DRAFT- DOH Review: Navy Groundwater Flow Models & Related Issues with the Navy CSM for the Red Hill Facility

The Department of Health Hawaii (DOH)
Technical subject matter experts
Robert Whittier, Don Thomas, G.D. Beckett & Anay Shende

October 19, 2021

Navy 3D Lithologic Model – Barrel Logs

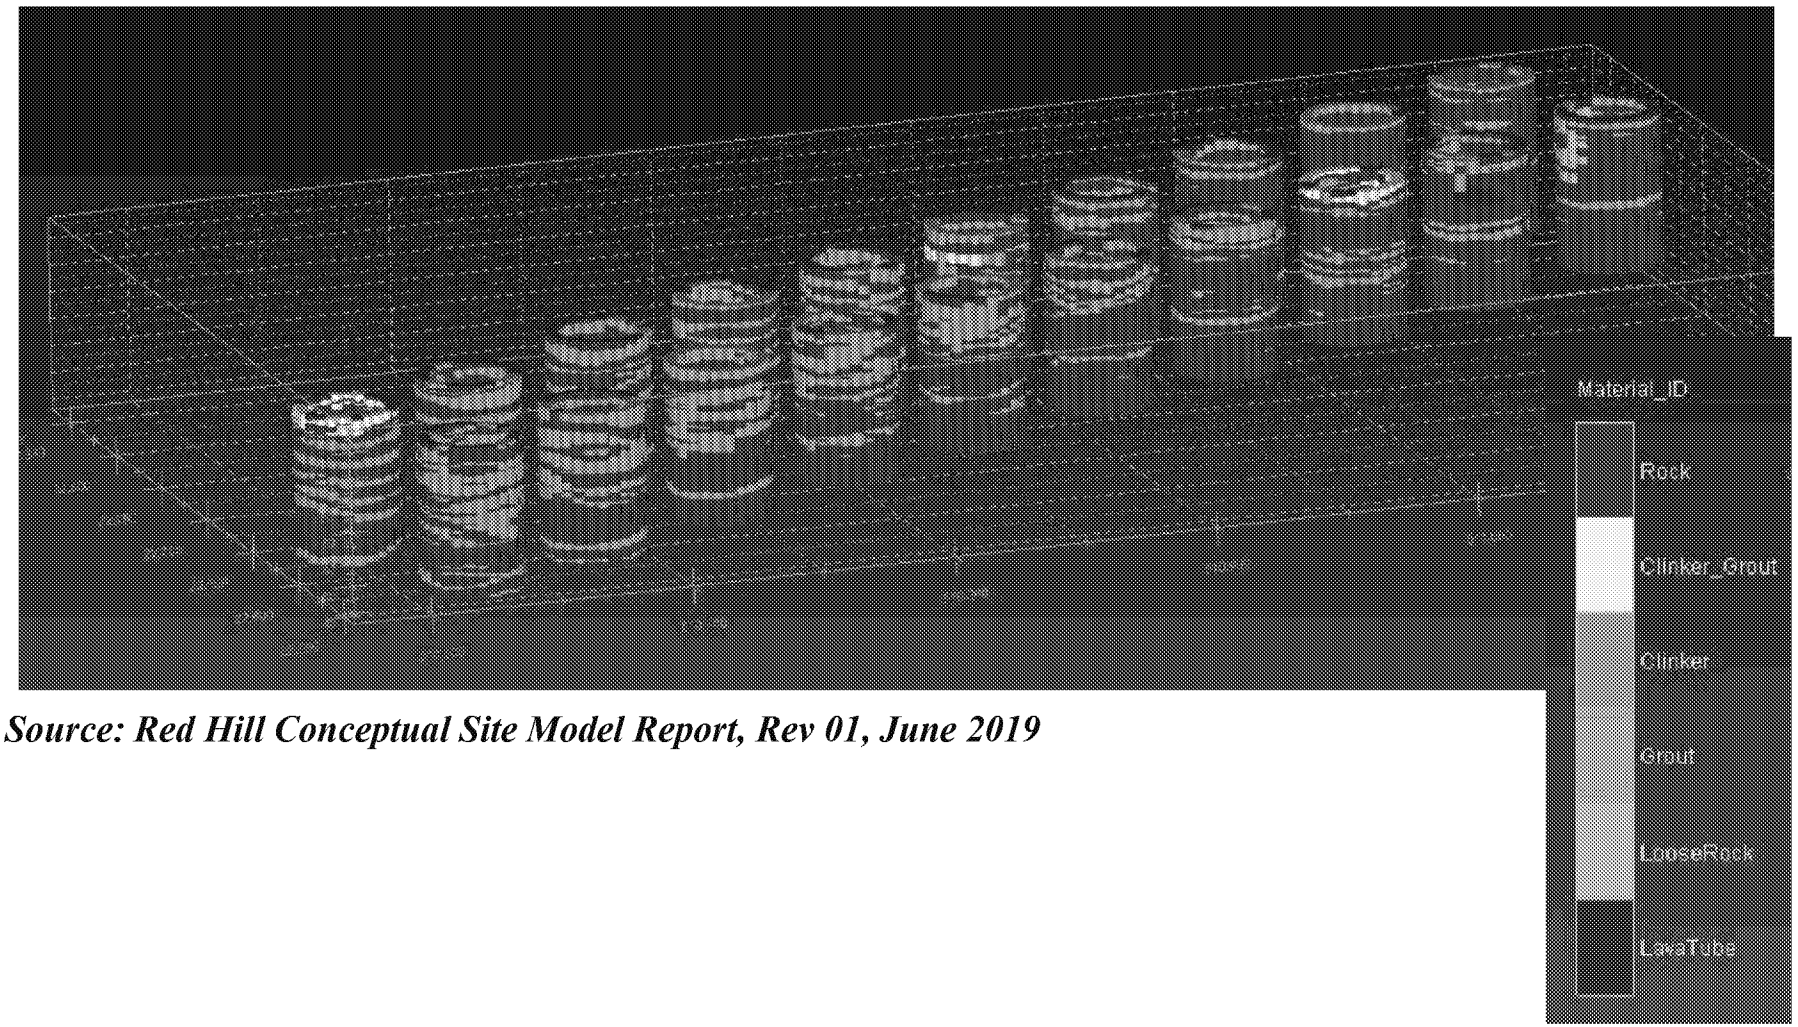
(same issue, Dr. Tonkin will address)
